## ANN ARBOR HISTORIC DISTRICT COMMISSION

### Staff Report

**ADDRESS:** 414 East Kingsley Street, Application Number HDC11-107

**APPLICATION:** The applicant seeks HDC approval to make an existing undersized basement egress window code compliant by extending it 7" deeper and enlarging the existing window well.

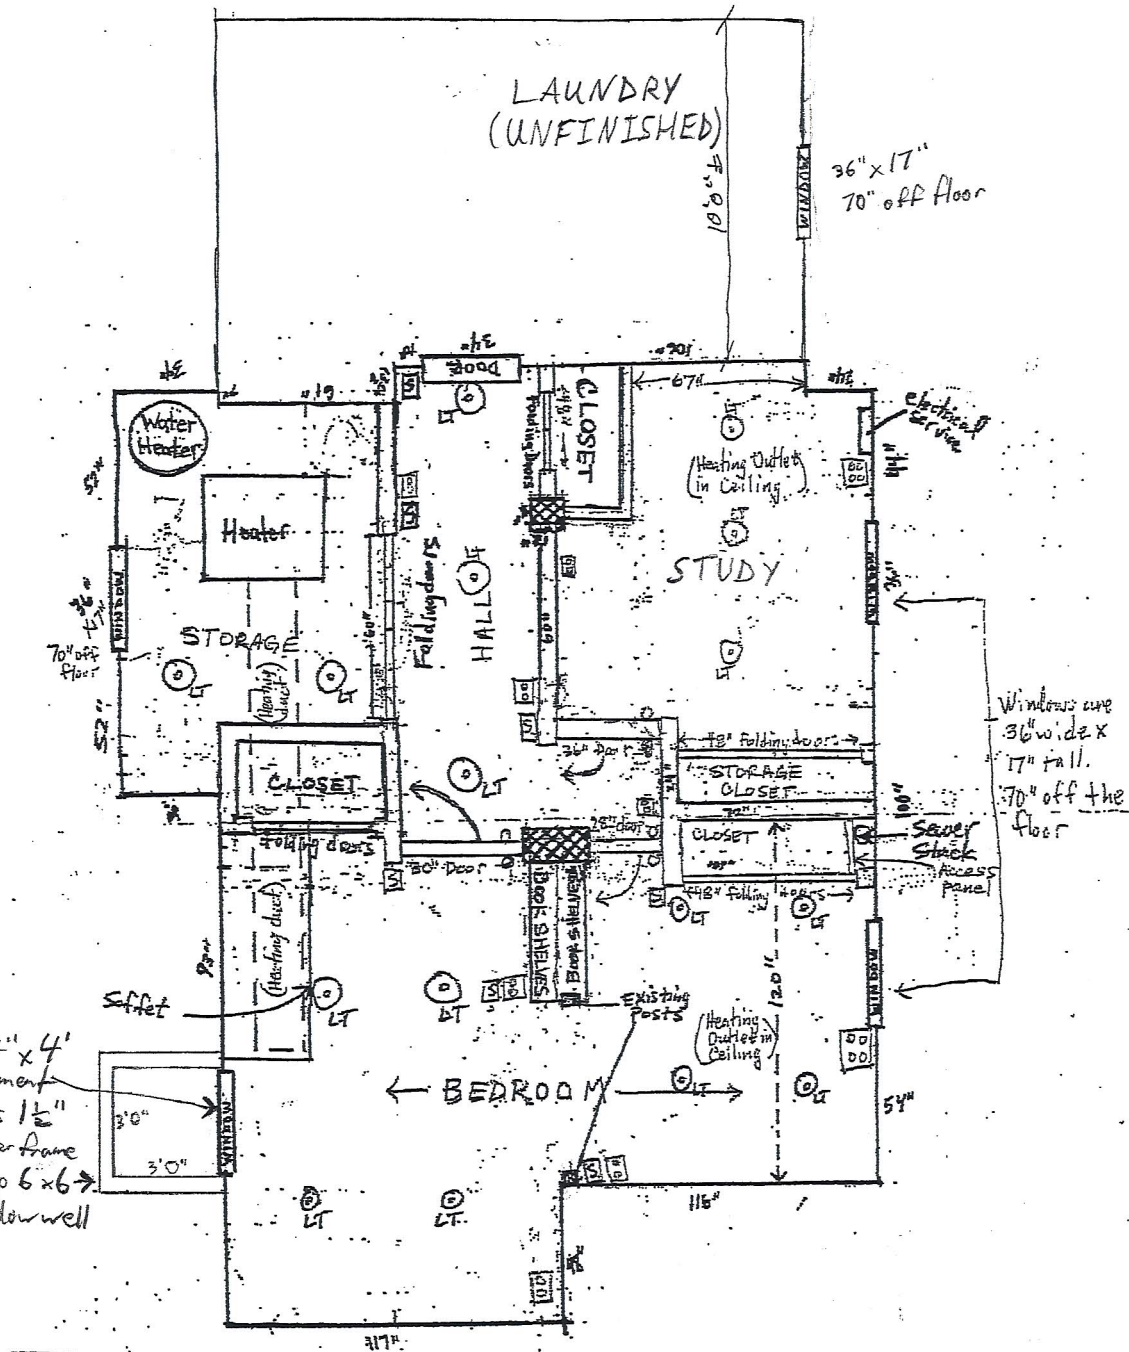
1. The current window was installed 5+ years ago and neither the window opening size nor the dimensions of the well are large enough to meet building code requirements for egress. The window opening would be extended seven inches deeper, and the well would be expanded eight inches in both directions and be reconstructed using similar six inch landscape timbers. The new window would be an Andersen vinyl clad casement.

2. The proposed alterations to this already altered basement window are minor and appropriate to insure safe egress while nominally affecting the building. A few flagstones will need to be moved a few inches away from the well on a nearby path.

3. Staff recommends approval of the application and finds it is generally compatible in design, arrangement, texture, material and relationship to the rest of the site and the surrounding area and meets *The Secretary of the Interior's Standards for Rehabilitation*, in particular standards 2, 9 and 10, and the guidelines for building site and district or neighborhood setting.

414 East Kingsley  
Ann Arbor

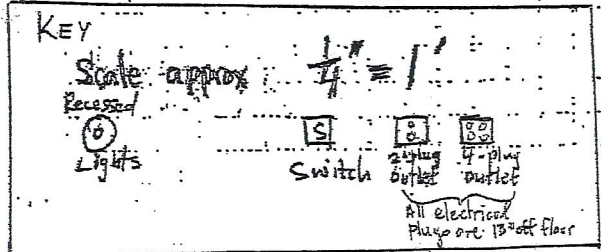
New 2'4" x 4' egress casement window plus 1 1/2" treated lumber frame 39"± deep 6x6 timber window well
